**Addendum No. 4**

RE: Contract # C204039

**Polk County (I-4729A)**

I-26/US-74/NC-108 Interchange Modifications in the Town Of Columbus

**Figure 1**

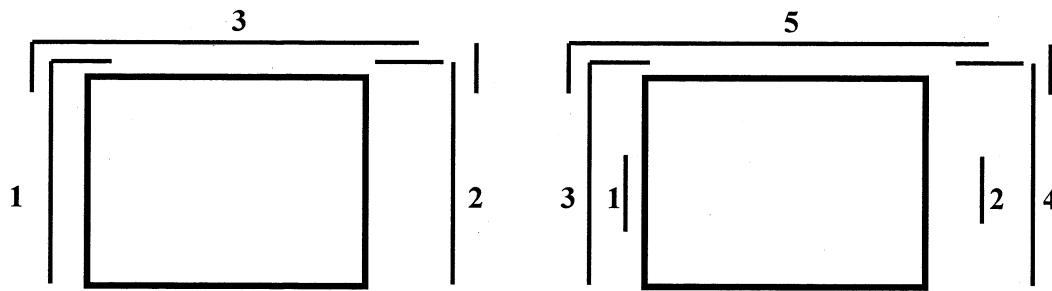
2. Seal the external joint with an outside sealer wrap conforming to ASTM C877 that is at least 12 inches wide and covers the joint on both the sides and the top of the box section. Use ConWrap CS-212 from Concrete Sealants, Inc., EZ-Wrap from Press-Seal Gasket Corporation, Seal Wrap from Mar-Mac Manufacturing Co., Inc., Cadilloc External Pipe Joint from Cadilloc, or an approved equal for the outside sealer wrap. If the outside sealer wrap is not applied in a continuous strip along the entire joint, a 12 inch minimum lap of the outside sealer wrap is permitted. Before placing the outside sealer wrap, clean and prime the area receiving the outside sealer wrap in accordance with the sealer wrap manufacturer recommendations. The joint wrap manufacturer installation recommendations shall be included with shop drawings submitted for review. The external joint wrap shall be installed in pieces, as indicated on Figure 1 below:
